# Statement of Response to An Bord Pleanála Opinion

## Proposed SHD

Lands at St Joseph's House  
and adjoining properties at  
Brewery Road and  
Leopardstown Road, Dublin 18.

This report is a response to the issues raised by An Bord Pleanála (ABP) in its Notice of Pre-Application Consultation Opinion dated 16 October 2020, in relation to a proposed strategic housing development and Leopardstown Road, Dublin 18. Case Reference ABP- 307355-20 refers.

Figure 5 - Pre-Application Separation Distances

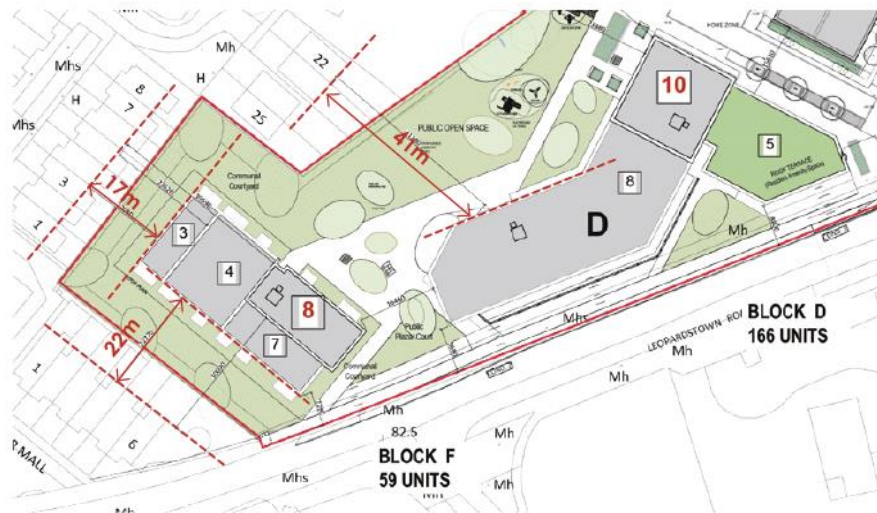
As set out above, Block F was redesigned following the issue of the ABP Opinion in order to improve the relationship with neighbouring properties and to provide an appropriate transition between the developments at Minstrel Court, Silverpines and Sir Ivors Mall.

As set out above, there has been a re-modelling of Block F to allow for a gradual transition from the residential neighbouring properties to St. Ivor’s Mall and Minstrel Court. Block F now facilitates a gradual scaling from the neighbouring properties to a 3 storey element and then on to a 6 storey element. This is the most sensitive boundary as it is the only part of the site which directly backs on to neighbouring gardens. Pre Planning Application and Current proposals for separation distances from Block F are identified below:

Evidently, minimum separation distances of 22m are now delivered along the boundary with Sir Ivors Mall and Minstrel Court. Separation Distances at the closest point are identified as 41m between Block D and properties at Silverpines.

Figure 10 – Separation Distances

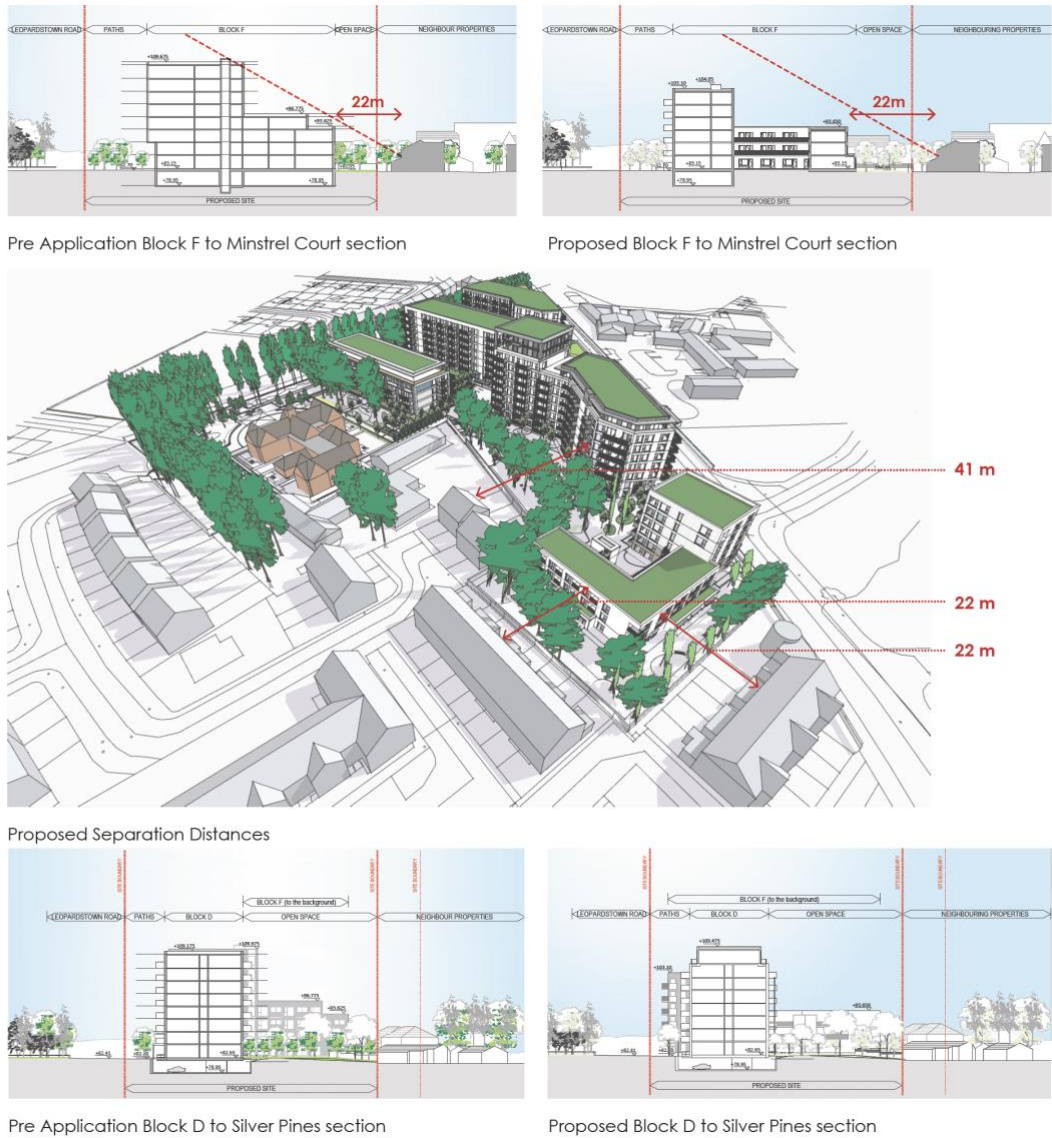
Further Consideration and/or justification of the documents as they relate to the impact of Block D & F on the residential amenity of both the occupants of the existing neighbouring dwellings and future occupants of the proposed development, having regard inter alia to the following:

- The location and design of blocks D & F to the rear of the neighbouring dwellings and the potential for a negative impact on the visual and residential amenity,
- The location of the proposed residential amenity areas on the upper floors, the levels of overshadowing on the proposed public open space areas and the potential for a negative impact on the residential amenity of the future occupants.

Block F (3-6 Storeys) serves as a transition from the boundary to Block D (5 – 10 storeys) which we see as being of justifiable height and scale for the development creating much needed street frontage onto Leopardstown Road. With Block C (5-7 storeys) now continuing with this rhythm along the street to anchor the greenway to the North East of the site. Separation Distances of up to 41m are now delivered between Block D properties at Silverpines.

Separation Distances from Blocks D and F to properties at Silverpines, Minstrel Court and Sir Ivors Mall are set out below for visual clarity:
